TOWN OF GLASTONBURY
GL-2021-05
GLASTONBURY HIGH SCHOOL ATHLETICS FACILITY
ADDENDUM NO. 2
December 10, 2020

A. RFI Questions and Answers:

C. Drawing Clarifications/ Revisions:

C-2.0

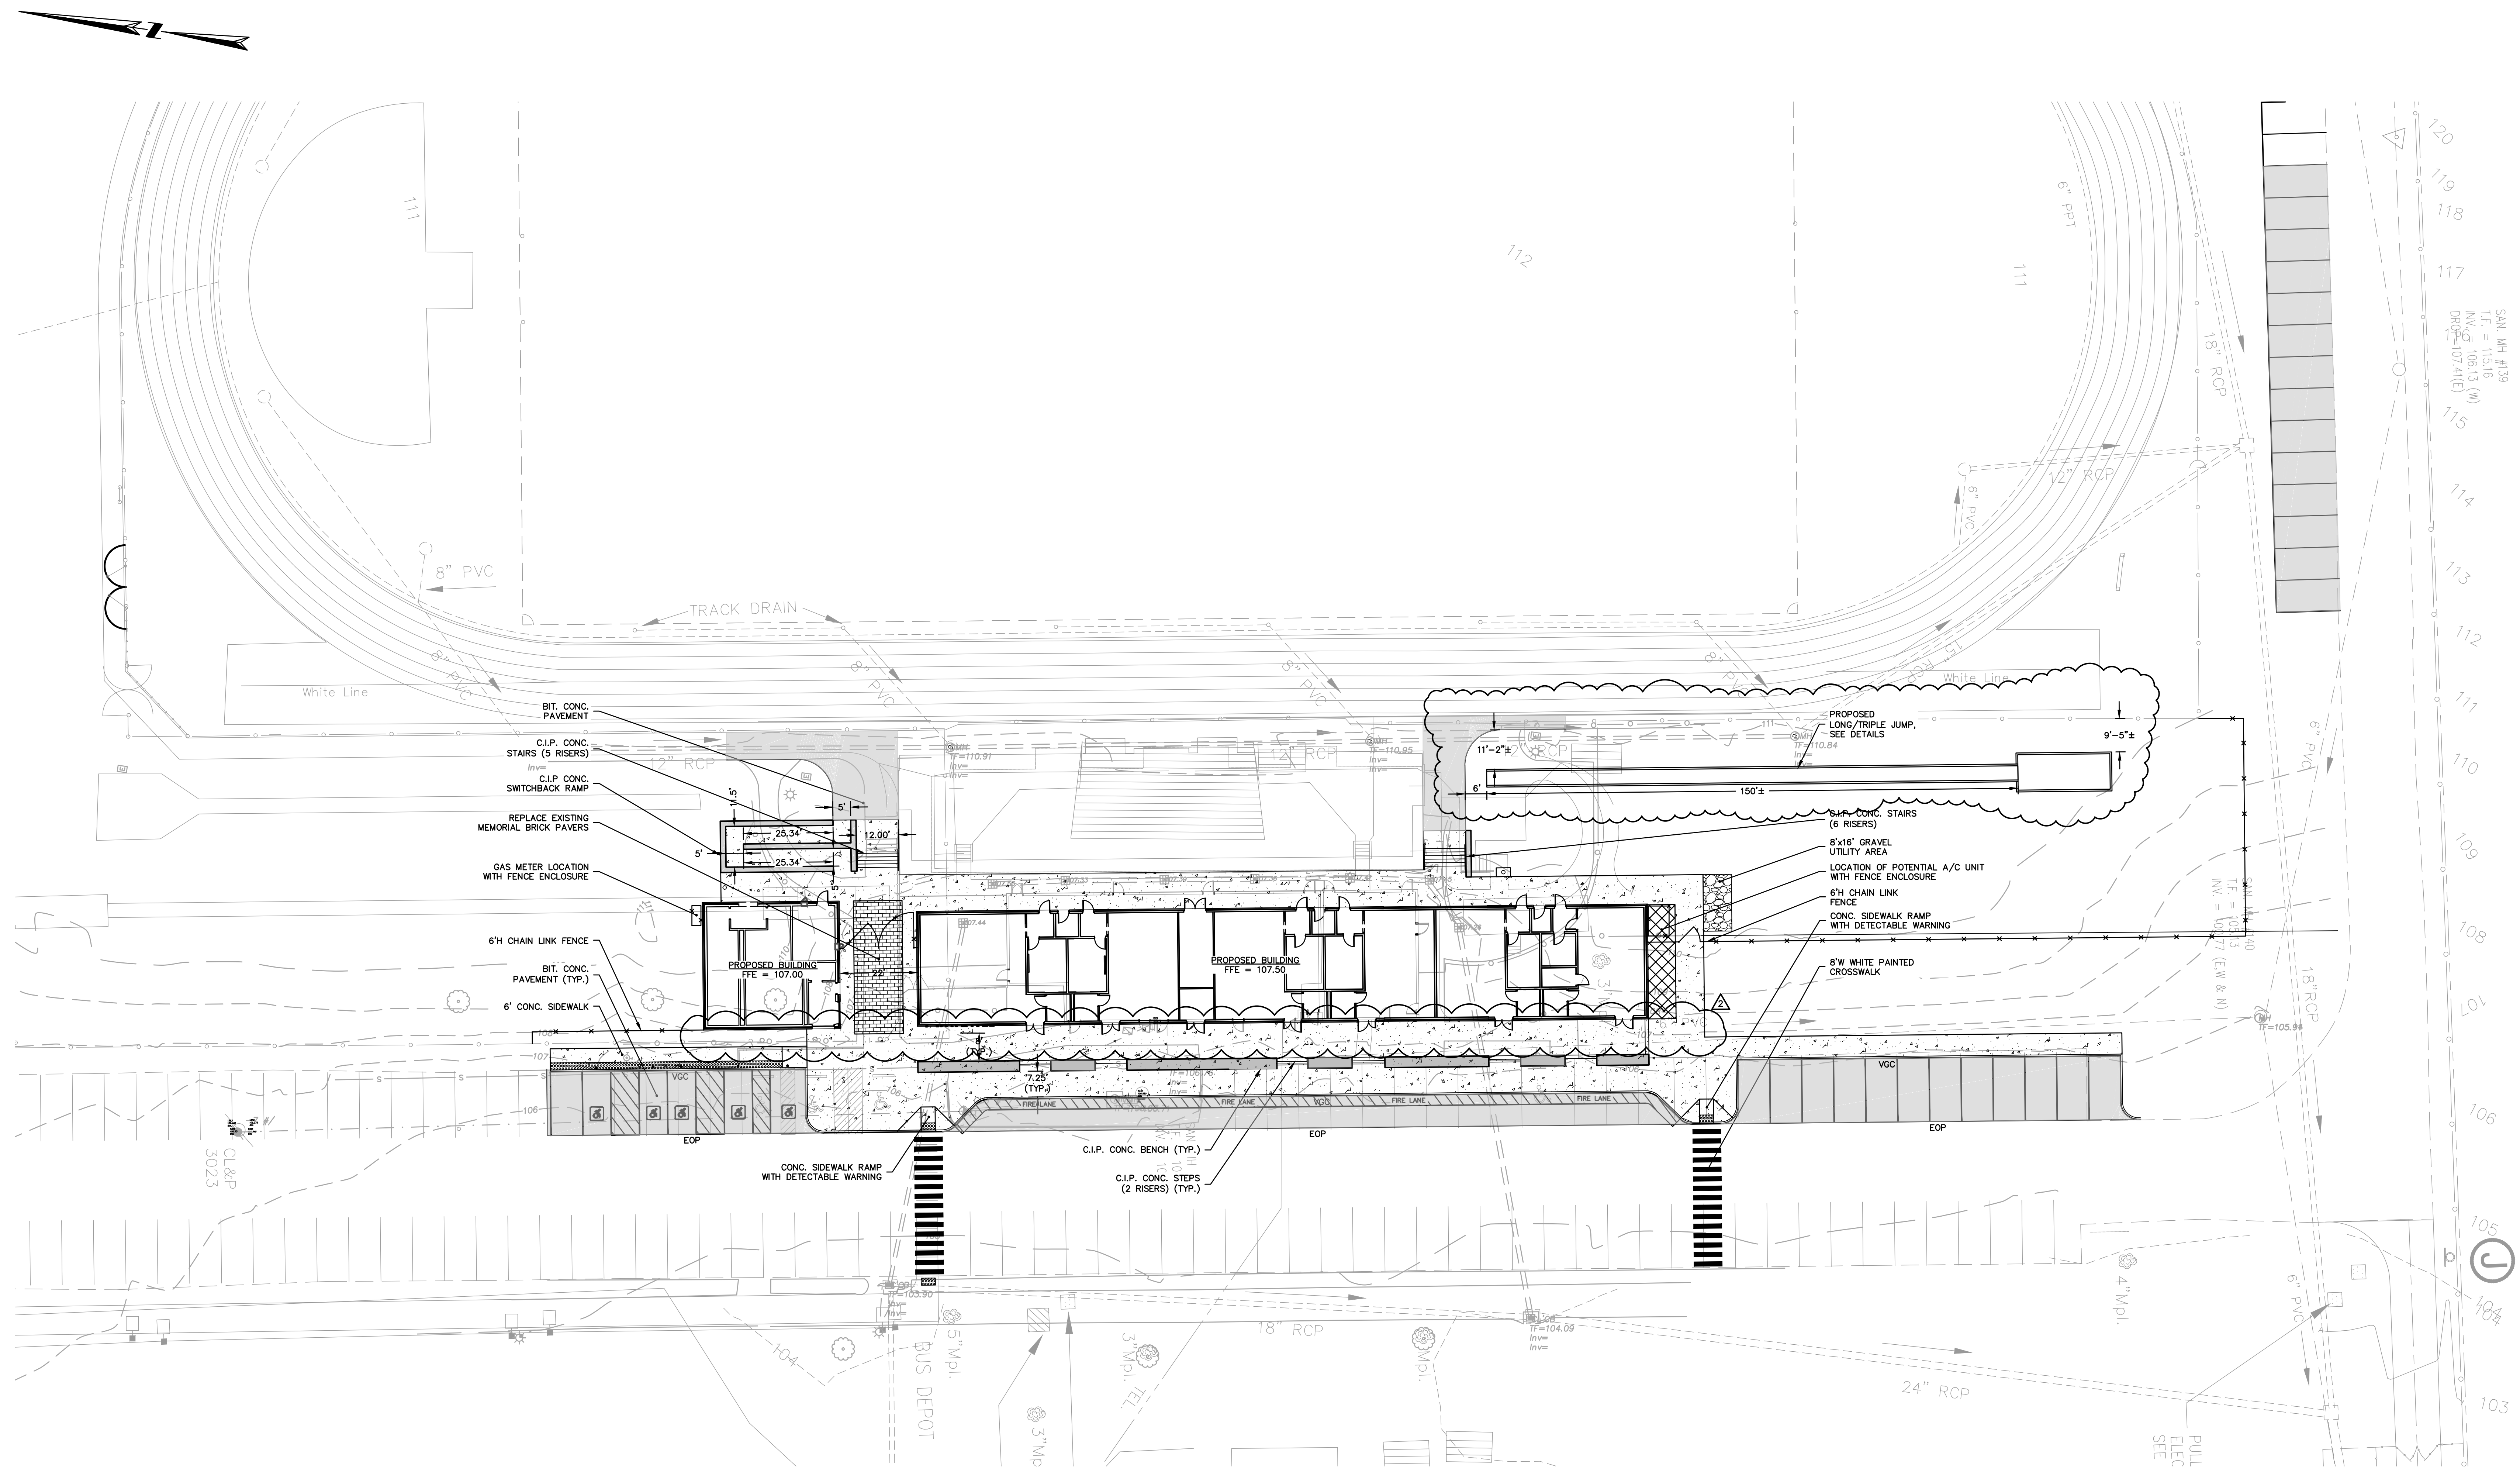
Question 20: *Please confirm all work shown on Site Preparation Plan C-2.0 is part of Alternate 3.*

Question 33: *C-2.0 indicates to remove and dispose of the long/triple jump track and sand pit. C-3.0 indicates "relocated long/triple jump". Please advise which drawing is correct. Is this base bid, Alternate 3, or is the owner taking care of this?*

Answer: Utility Demolition and Abandonment within Site Preparation Plan C-2.0 is part of Alternate 3. Remaining items belong to the base bid.

Answer: The long/triple jump will be removed and a new one will be provided as part of the base bid.

Drawing Number	
C-3.0

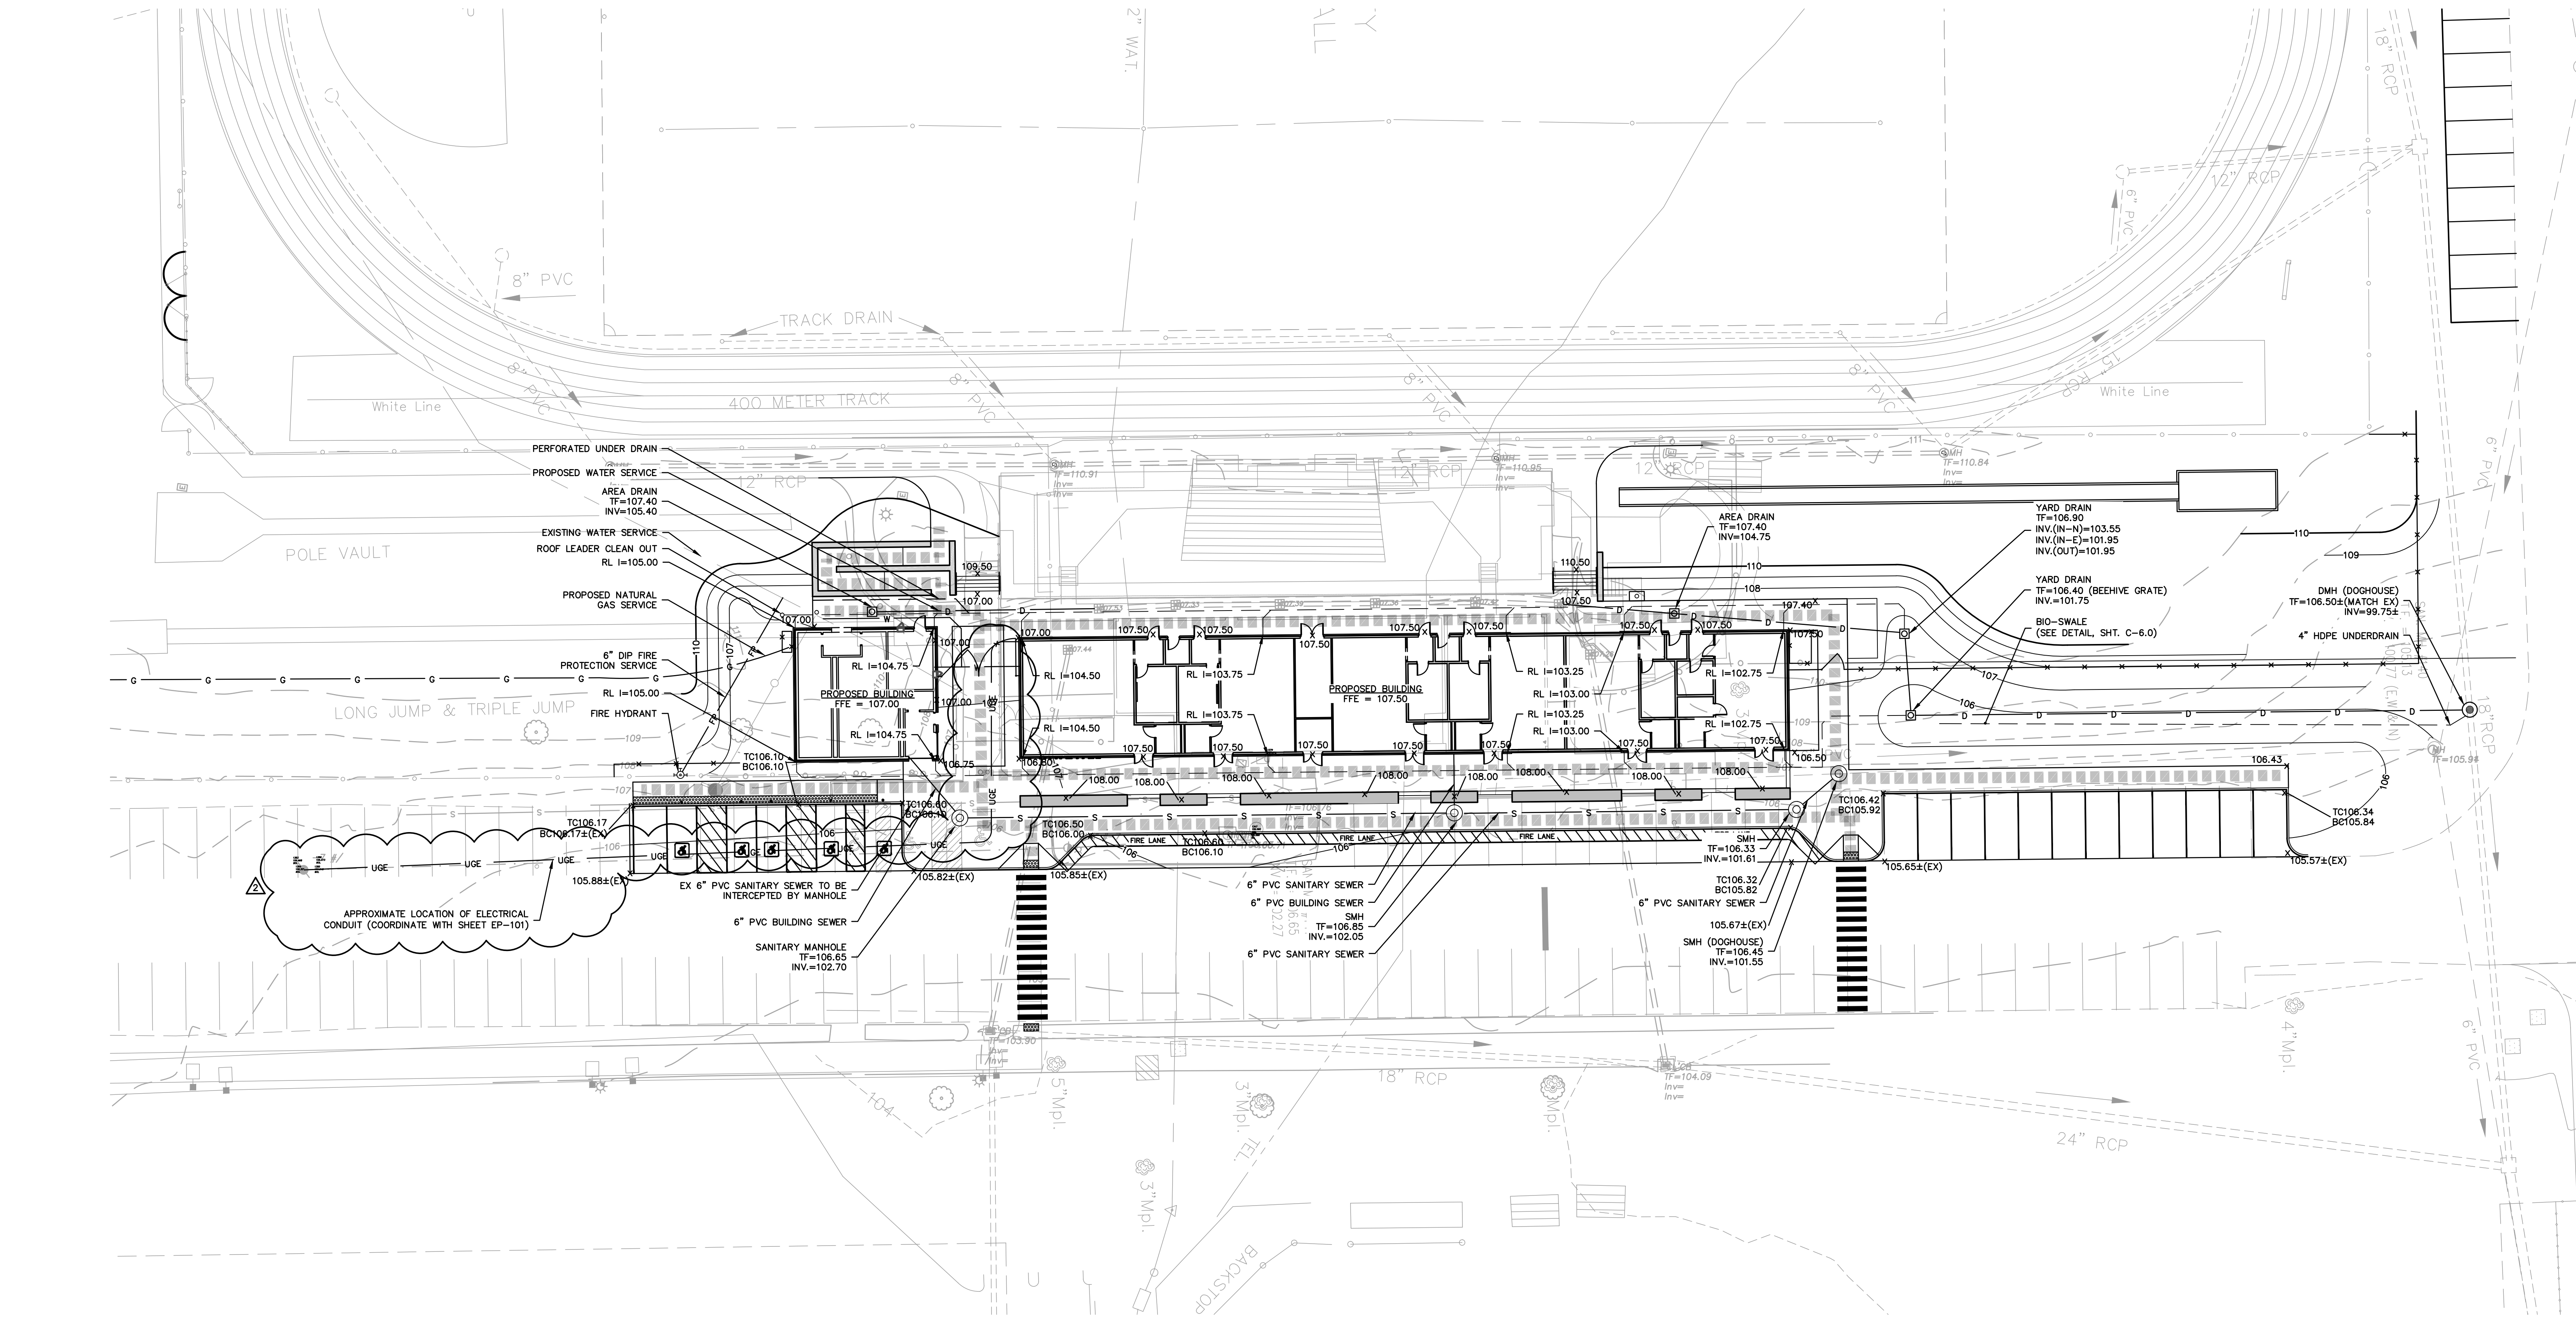
Question 5: *Can dimensions be provided for the new switchback ramp on the Civil drawings?*

Question 6: *Do the 2-riser steps between the Cast-In-Place concrete benches on drawing C3.0 require railings? Please advise.*

Question 32: *C-3.0 appears to show a gate between the 2 buildings. What is the material of this gate?*

Question 39: *There is another area shaded shown with parking spaces on the right side of drawing C3.0. Is this area also part of the project?*

Answer: Dimensions have been added to Sheet C3.0

Answer: The steps do not require railings.

Answer: The gate is black coated vinyl chain link fence. See detail on Sheet C-6.0.

Answer: Yes, that is another section of parking added.

C-5.0

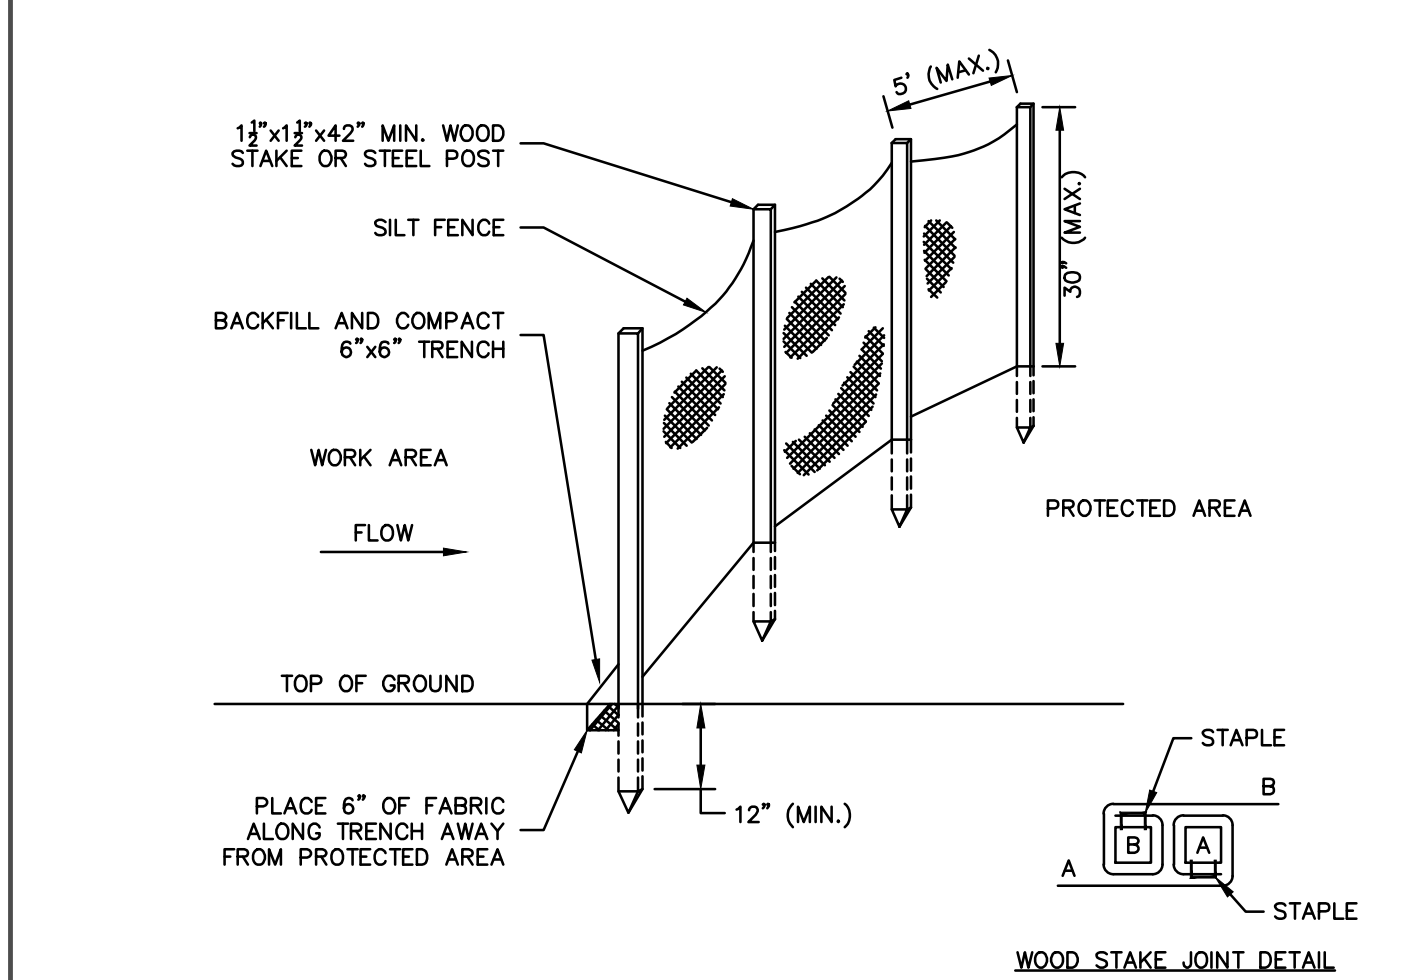
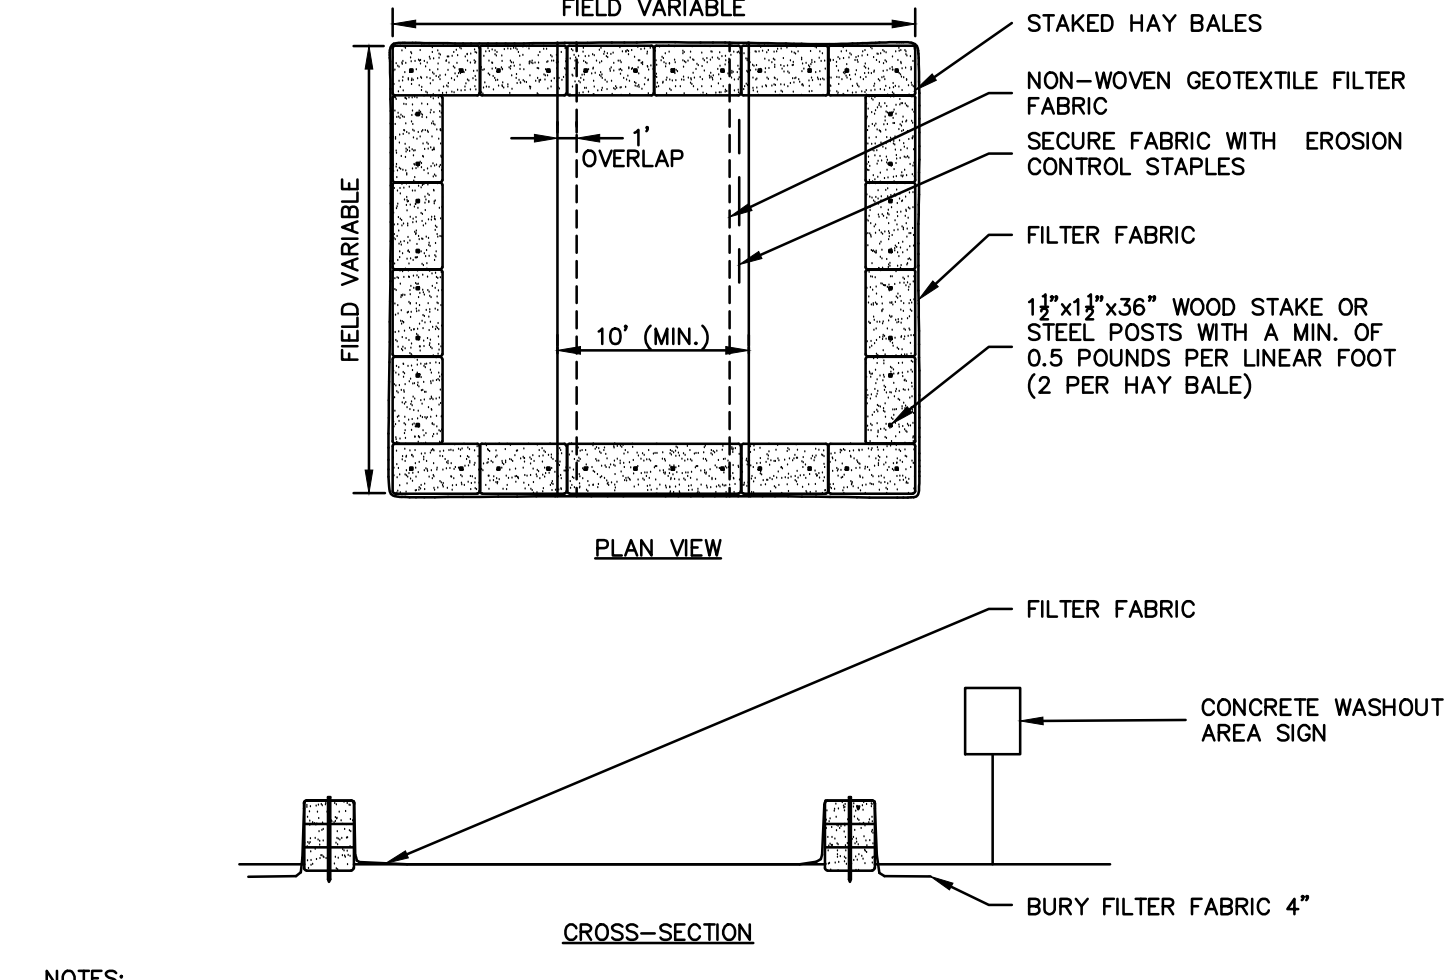
Question 35: *C-5.0 the plants and quantities between the plan and the schedule on the plan do not match. Example, right side of the locker building calls for 2 – GI and 6 – EC, the plant schedule has neither GI nor EC. Plants listed on the schedule do not appear on the plan. Please advise.*

Answer: The Planting Plan has been revised. See Sheet C-5.0.
